ADDENDUM #1 – SEPTEMBER 9, 2021

RE: DOUGLAS COUNTY
SALMON HARBOR MARINA OFFICE ADDITION
Project #19.64

FROM: HGE ARCHITECTS, Inc.
333 South 4th Street
Coos Bay, Oregon 97420
541-269-1166

1 Section 1
A3.1 SCALE: 3/8" = 1'-0"

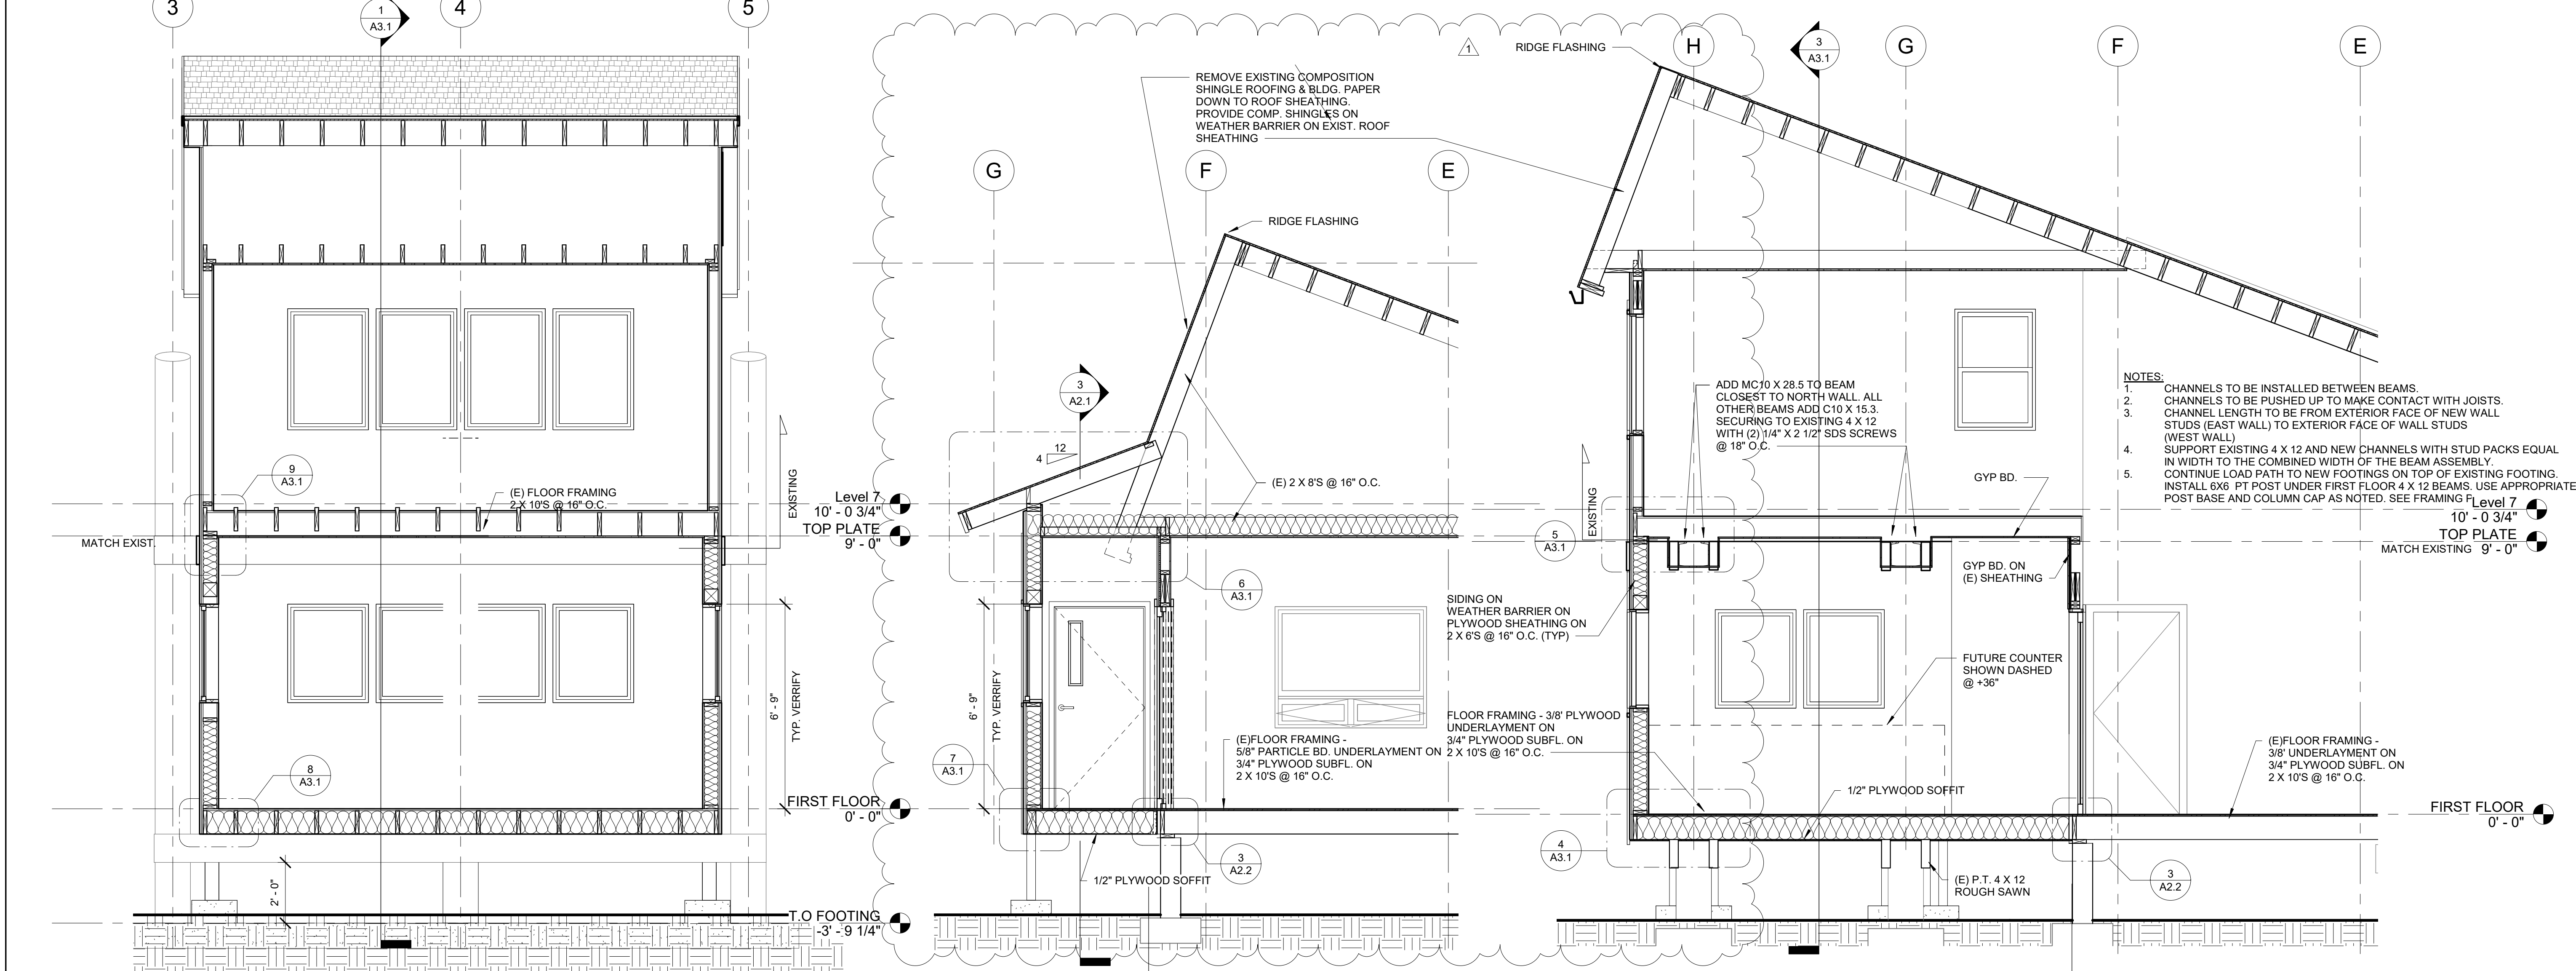
1. **Sheet A3.1, Building Sections: See attached REVISED Sheet A3.1.**
 - a. Drawing 1/A3.1 Section 1 - ADD the following note to steep section of upper floor existing roof: "Remove existing composition shingle roofing and building paper down to roof sheathing. Provide composition shingles on weather barrier on existing roof sheathing".

1 EAST ELEVATION
A4.1 SCALE: 1/4" = 1'-0"

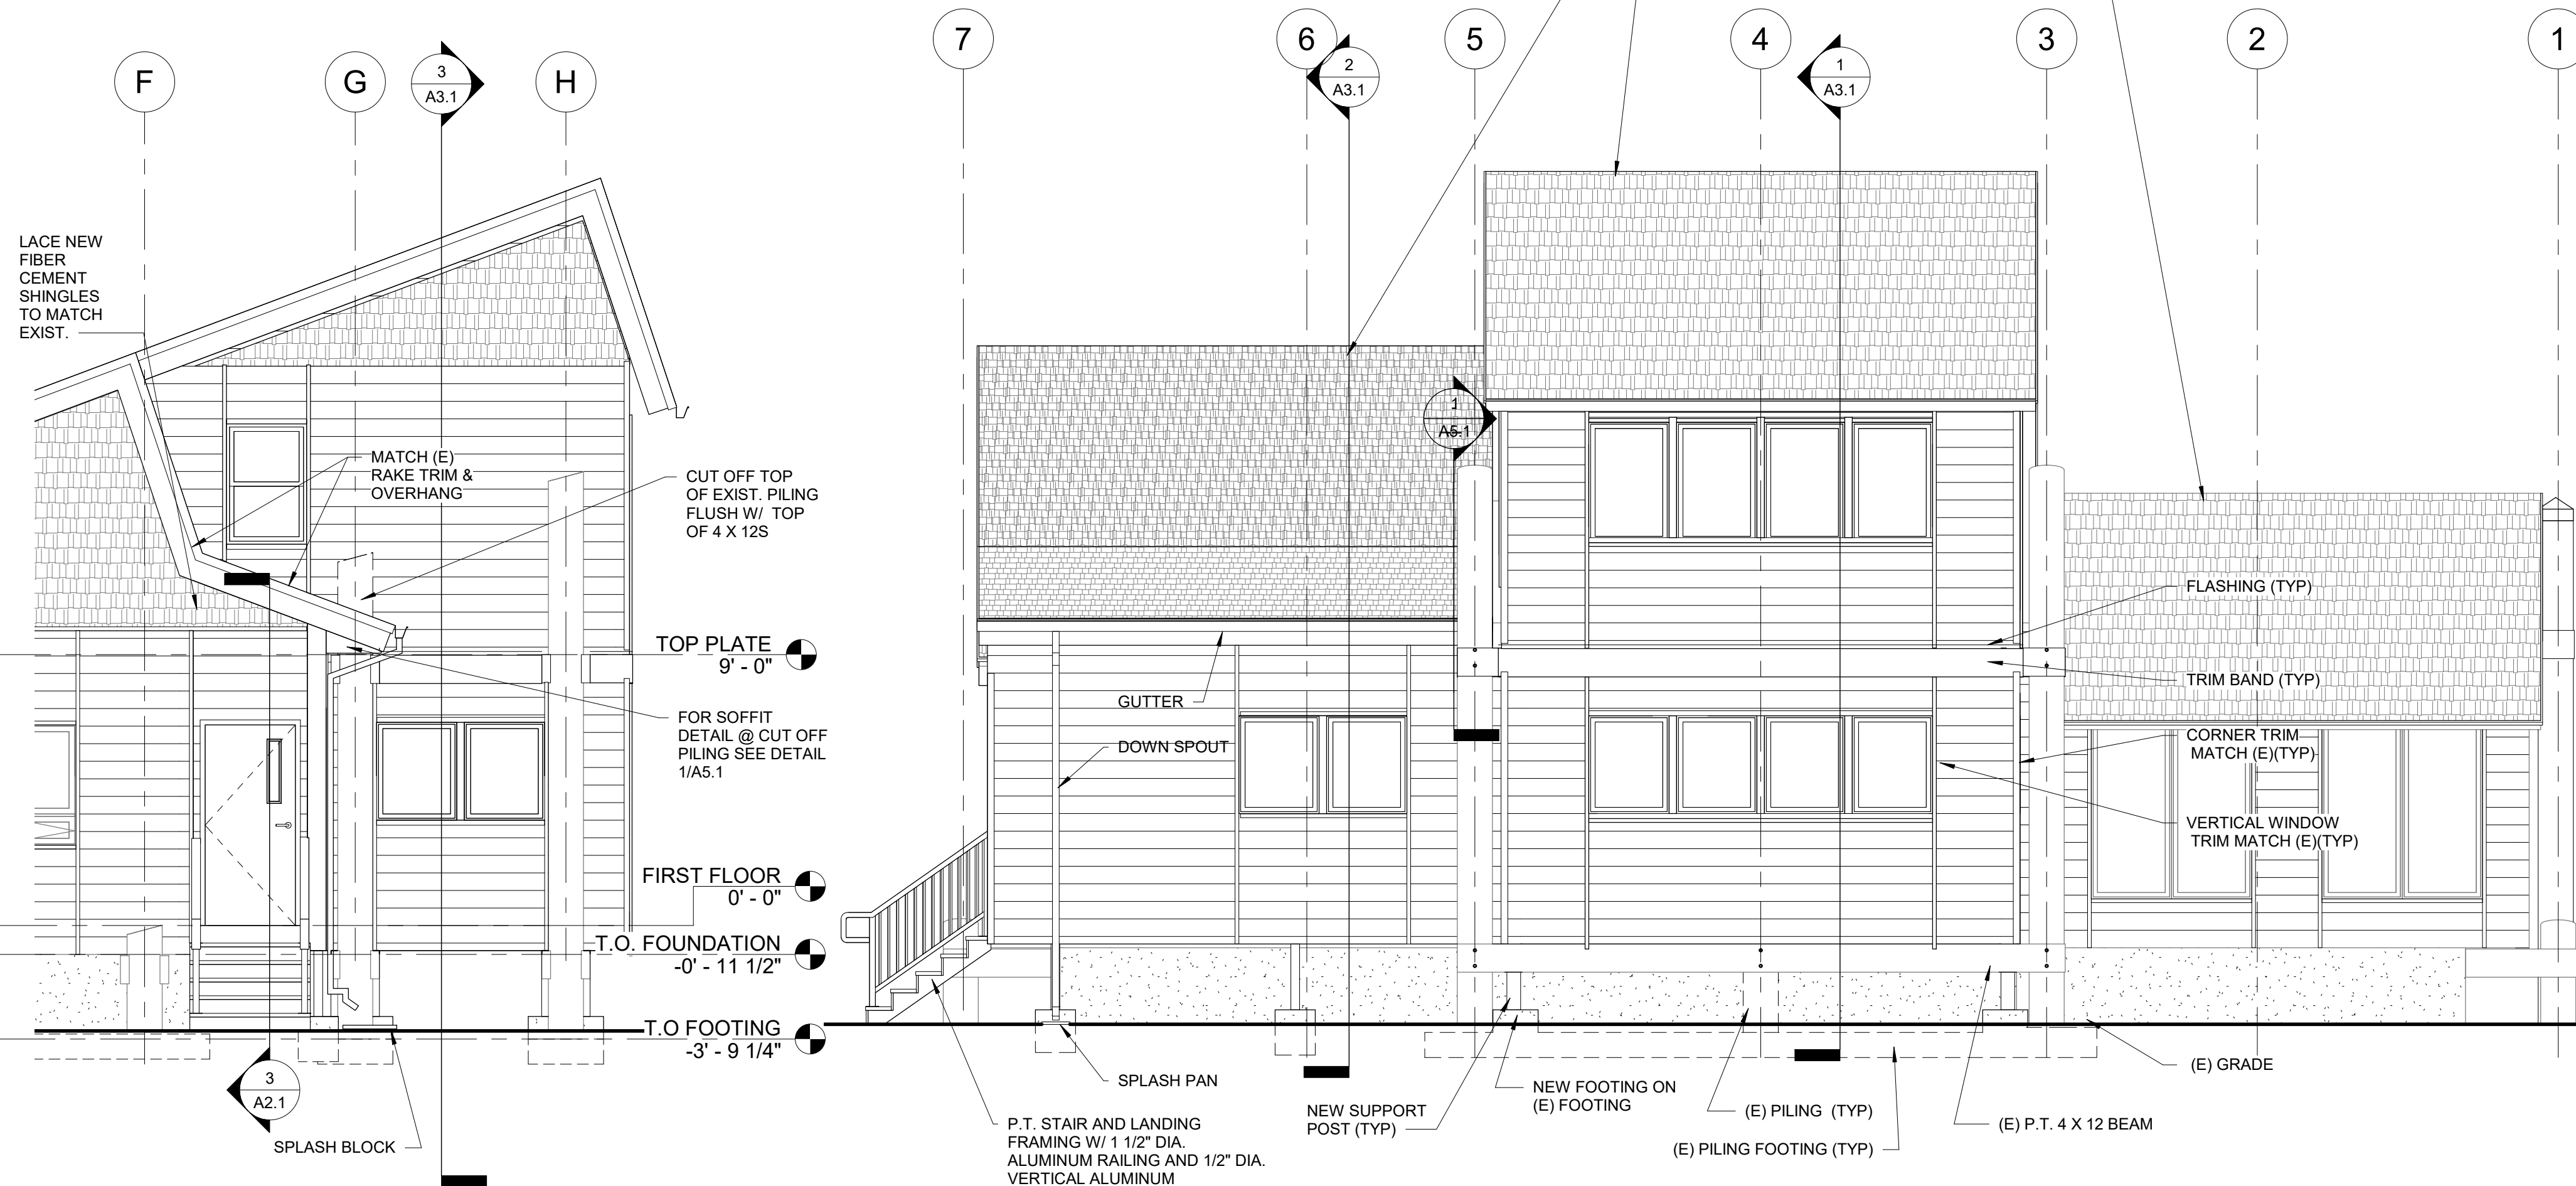
2. **Sheet A4.1, Exterior Elevations: See attached REVISED Sheet A4.1.**
 - a. Drawing 1/A4.1 East Elevation – ADD the following note: "Cut off top of existing piling flush with top of 4x12's".

2 NORTH ELEVATION
A4.1 SCALE: 1/4" = 1'-0"

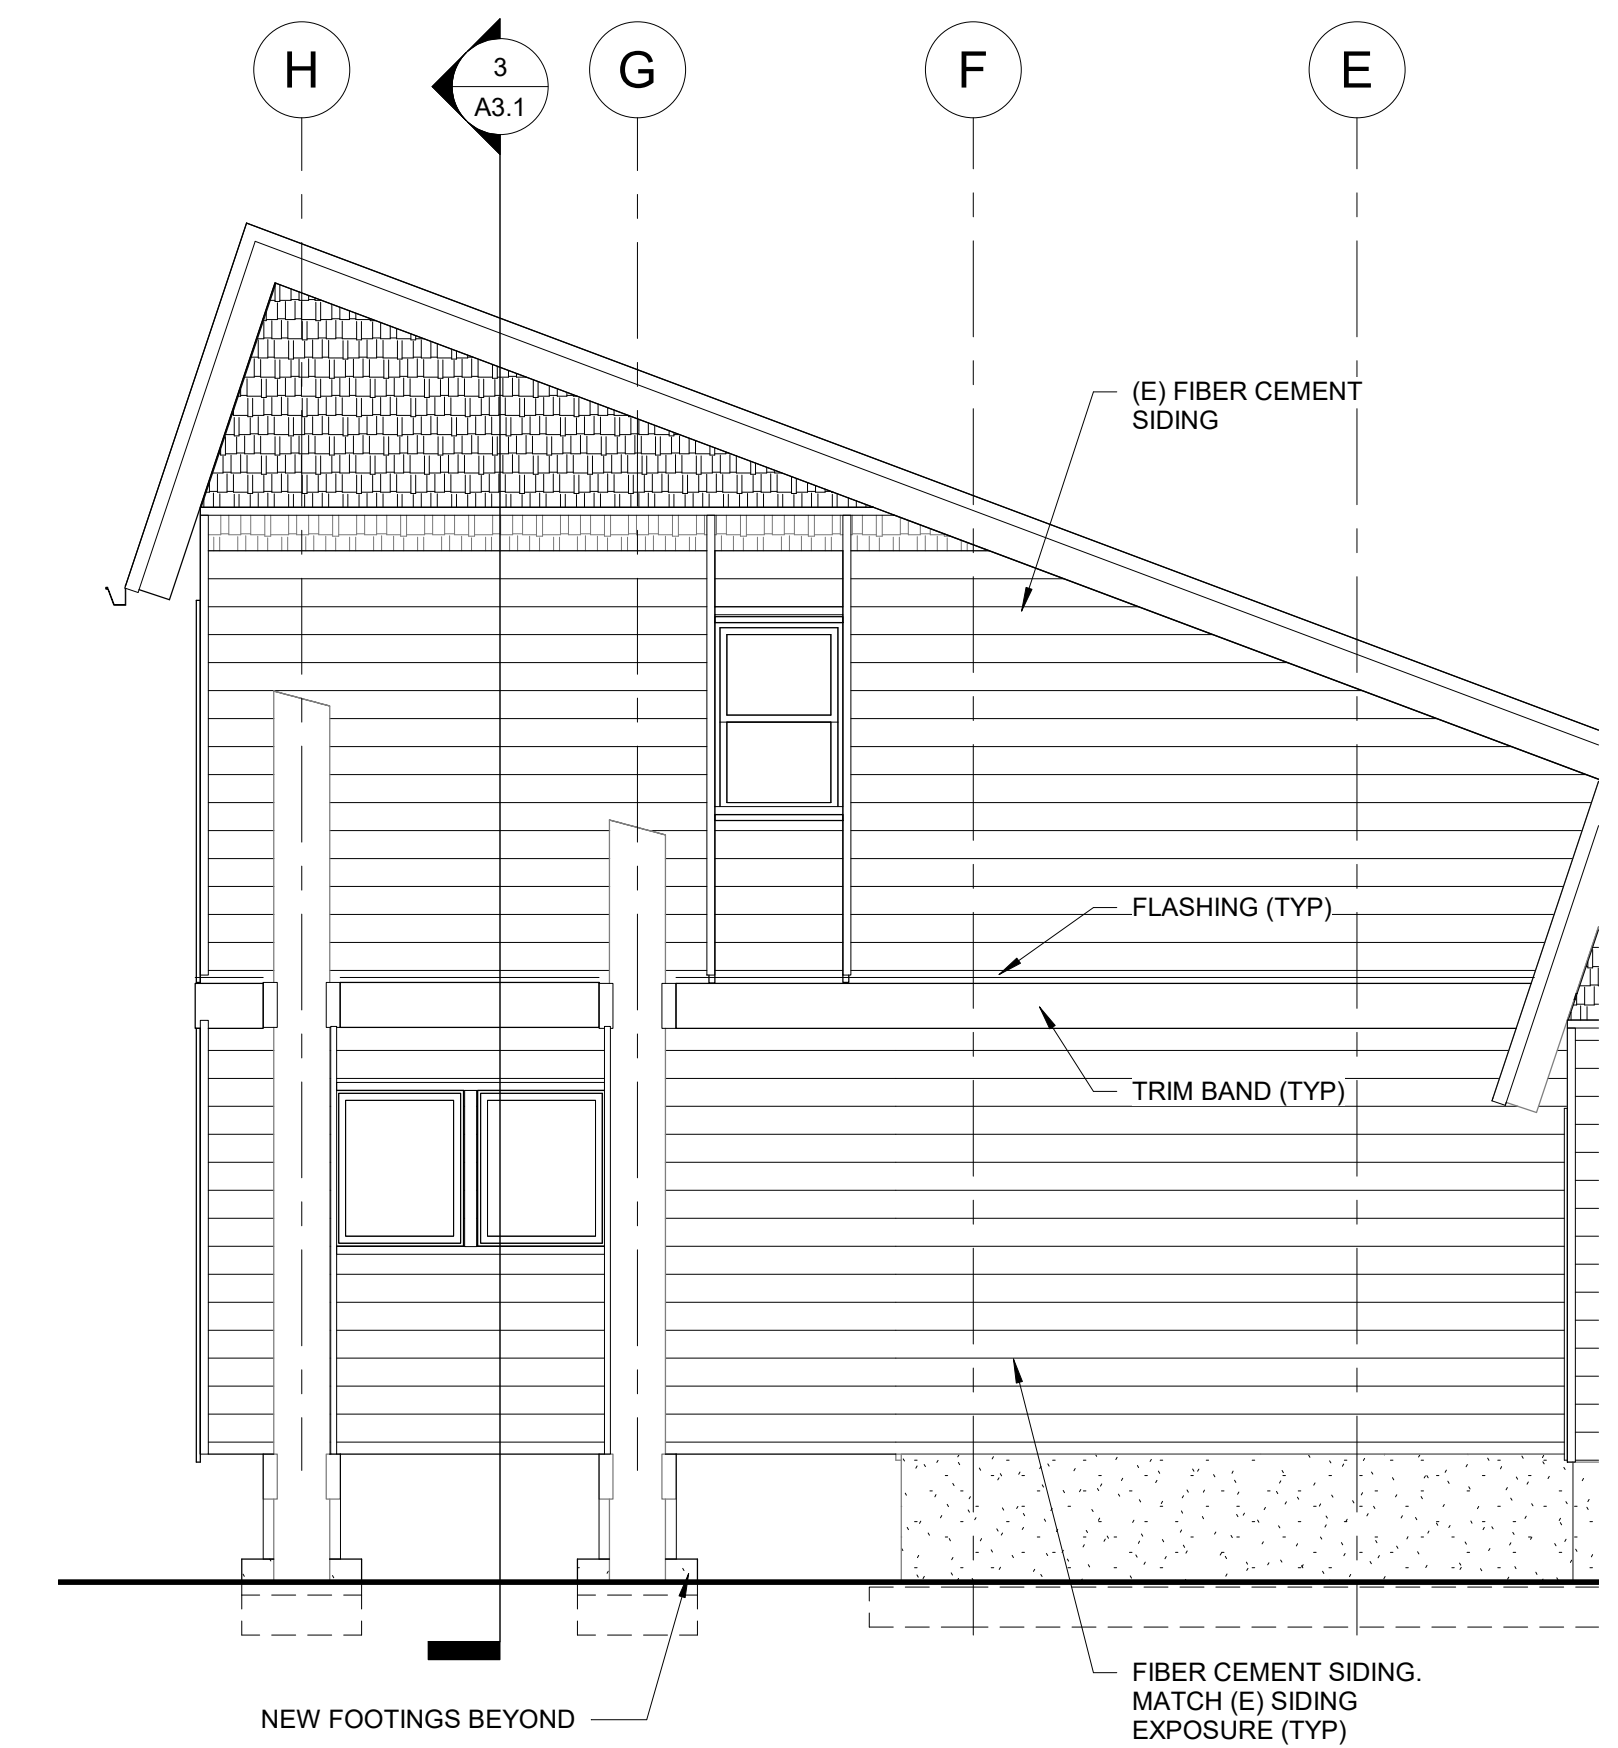
- b. Drawing 2/A4.1 North Elevation – ADD the following note: "All north facing existing composition shingle roofs are to be reroofed. Remove existing composition shingle roofing and building paper down to existing roof sheathing. Provide composition shingles as specified on weather barrier on existing roof sheathing."

NOTE:
ALL NORTH FACING EXIST. COMP. SHINGLE ROOFS ARE TO BE REROOFED. REMOVE EXIST. COMP. SHINGLE ROOFING & BLDG. PAPER DOWN TO EXIST. ROOF SHEATHING. PROVIDE COMP. SHINGLES AS SPECIFIED ON EXIST. ROOF SHEATHING.
